**NORTH CAROLINA  
PUBLIC STAFF  
UTILITIES COMMISSION**

Re: Docket No. E-100, Sub 190 – Biennial Consolidated Carbon Plan and Integrated Resource Plans of Duke Energy Carolinas, LLC, and Duke Energy Progress LLC, Pursuant to N.C.G.S. § 62-110.9 and § 62-110.1(c)

**DOCKET NO. E-100, SUB 190**

In the Matter of	)	
Biennial Consolidated Carbon Plan and	)	<b>TESTIMONY OF</b>
Integrated Resource Plans of Duke	)	<b>JEFF THOMAS</b>
Energy Carolinas, LLC, and Duke	)	<b>PUBLIC STAFF –</b>
Energy Progress, LLC, Pursuant to	)	<b>NORTH CAROLINA</b>
N.C.G.S. § 62-110.9 and § 62-110.1(c)	)	<b>UTILITIES COMMISSION</b>

Figure 1: Carbon Constraints used in the CPIRP

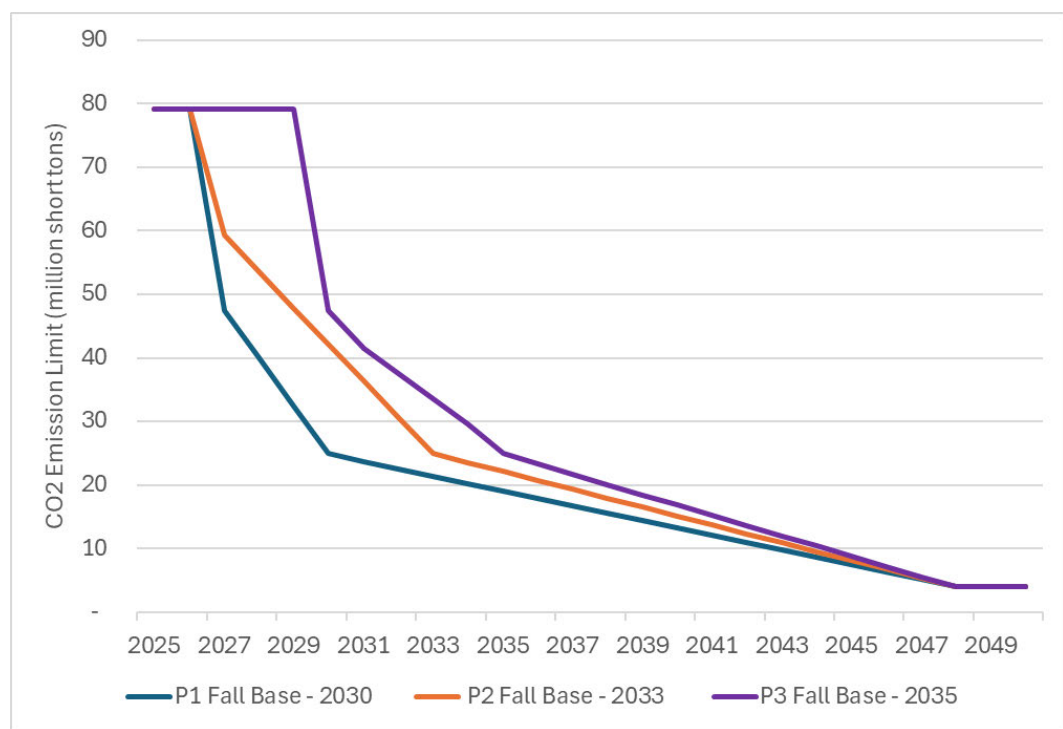
1           The carbon constraints used by the model are shown in Figure 1  
2 below. Notably, Duke models the interim target at approximately 24.9  
3 million short tons. While this target is technically higher than the  
4 interim target of 22.8 million short tons approved in the 2022 Carbon  
5 Plan Order,<sup>14</sup> the difference is due to the Companies' fossil fuel-fired  
6 units located in South Carolina.<sup>15</sup> The modified CO<sub>2</sub> limit was  
7 designed to be imposed as a system-wide limit that would result in a  
8 system that meets North Carolina requirements without relying on  
9 uneconomic dispatch of South Carolina generators.

5 Figure 3: P3 Fall Base Winter Reserve Margin

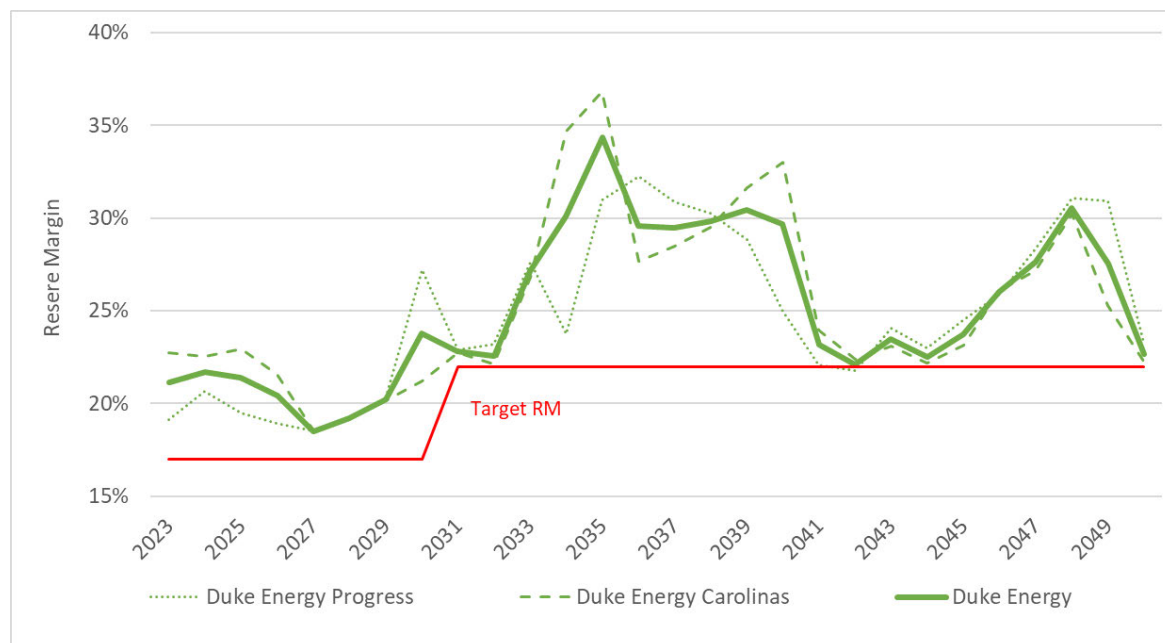
12 A. The modeled winter reserve margin for P3 Fall Base is shown in  
13 Figure 3 below.<sup>30</sup> Because the reserve margin constraint is just one  
14 of many constraints that influence resource selections, it is evident  
15 that the winter reserve margin is higher than needed for most of the  
16 planning horizon. However, there are several key periods where the  
17 reserve margin drives the need for new resources: in approximately

Figure 5: Marginal Winter ELCC Curves for Wind, Four-Hour Batteries, and Solar

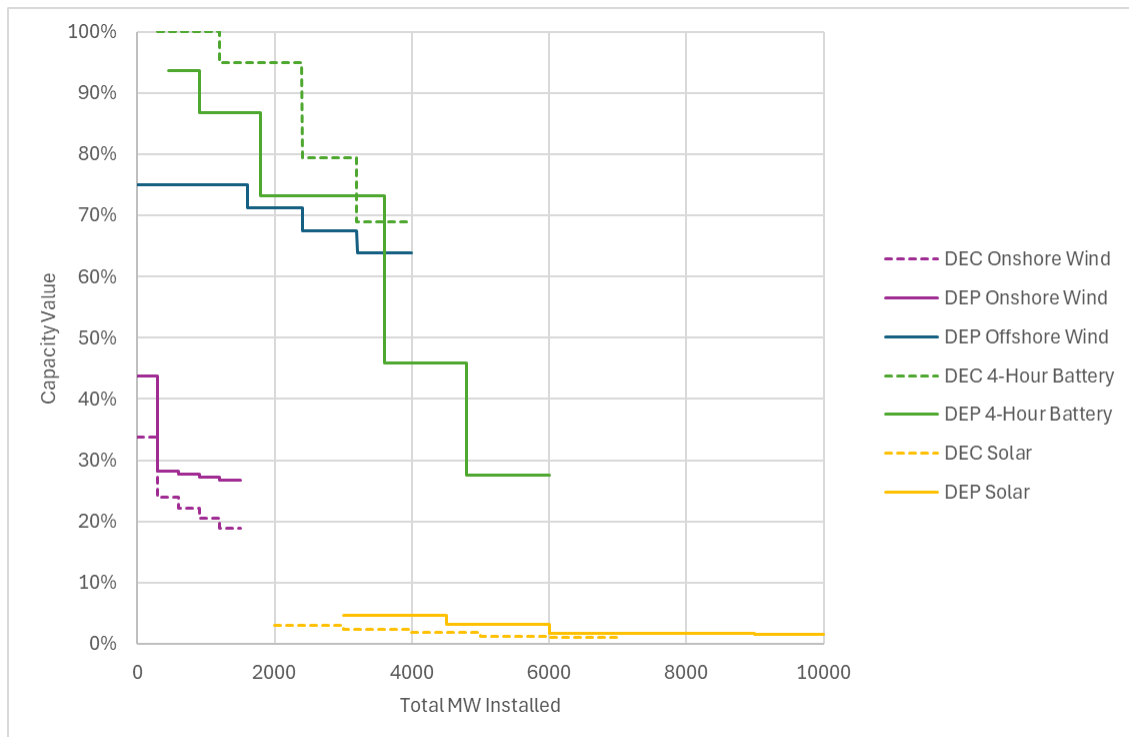
3 A. No. The ELCC studies employed by the Companies create an ELCC  
4 curve, which generally shows that as more of a particular resource is  
5 added, the capacity value of that resource decreases.<sup>31</sup> The  
6 marginal winter ELCC curves for wind, solar, and four-hour batteries  
7 are found in Figure 5 below.<sup>32</sup>

4 These declining ELCC curves are modeled in EnCompass, which  
 5 assigns an incremental capacity value to new resources that  
 6 depends upon the cumulative amount of the resource that has been  
 7 added.

Figure 9: CO<sub>2</sub> Emissions and Exceedances in 2030 Portfolios

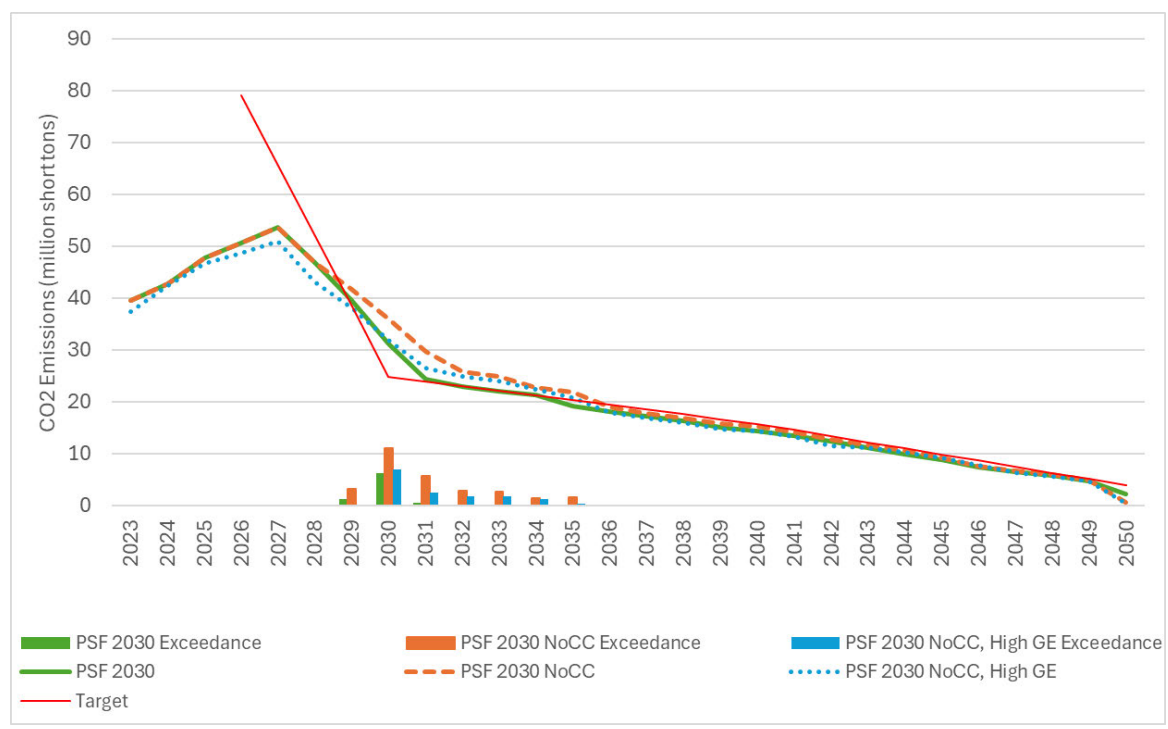
- 1   **Q.    Putting aside the scale of resource additions required to meet**  
2       **the interim compliance target by 2030, did these simulations**  
3       **meet the carbon cap?**
- 4    A.    No. In both cases where no CC was added, the model was overly  
5       constrained and was unable to meet the CO<sub>2</sub> limit, as shown in  
6       Figure 9.<sup>77</sup> The model run with no CCs and base grid edge  
7       assumptions did not comply with the interim target until 2034; when  
8       the high grid edge sensitivity was included, the interim target was  
9       met in 2032. While the 2030 portfolio had fewer exceedances when  
10      it was allowed to build CCs, it still violated the limit in 2030, and the  
11      interim compliance target was not achieved until 2031.
